**Re. Further groundwater response to Council further information requests for the resource consents for EB3C and EB4L Application Packages**

## EB3C and EB4L RCs – Groundwater Queries

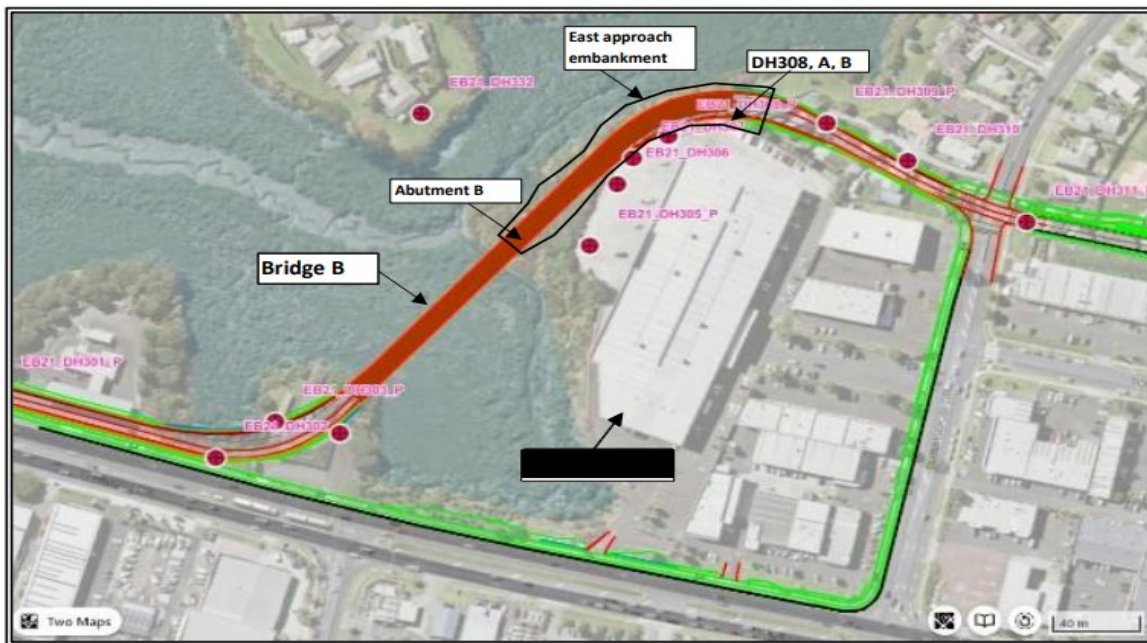
*The GWE report states: "Settlement of the embankment fill is expected to occur during preloading, while the embankment is consolidating. The China Town building is approximately 11 m away at the nearest point to the embankment. The zone of influence around the embankment will be estimated during design phase, and if required a monitoring plan will be implemented"*

- 9. In addition, we have additional query 9 below: Please provide a plan showing the zone of influence of settlement around the embankment and assess the effects on the China Town Car Park & Building and provide a draft Groundwater Settlement Monitoring and Contingency Plan (GSMCP) to include details and frequency of visual inspections and pre and post construction detailed condition surveys of buildings/structures and public services. If a draft GSMCP, visual inspections and conditions surveys are not considered necessary this should be fully justified. This information is required with the RC Application not at a later date.*

Section 3.3.5 of the Groundwater Effects Assessment (Appendix 24) notes that: *"The soft ground is expected in the coastal marine area where the sediments are softest, and settlement reduces rapidly up the existing slopes. Settlement is not expected in the existing carpark of the Chinatown retail business as this lies on top of basalt which is underlain by stiff Tauranga Group. The embankment fill is greater than 20m away from the existing buildings at the nearest point and no settlement on the existing structure will occur due to the work".*

*“At the nearest point to the carpark and building, the proposed embankment is less than 4m thick. The worst-case predictions at this point show that settlement will be nil or negligible beyond 6m from the embankment. The building is 11m away from the embankment, beyond the zone of influence. Further to this, drill hole log for DH308 shows that the carpark between the building and the embankment is underlain by 4m of basalt rock, which is not prone to settlement affects. This confirms that a GSMCP is not necessary.”*

Please refer to the drill hole log for DH308 (**Attachment 3**).

Set out below is a copy of Figure 11 from the Groundwater Effects Assessment showing the location of DH308:
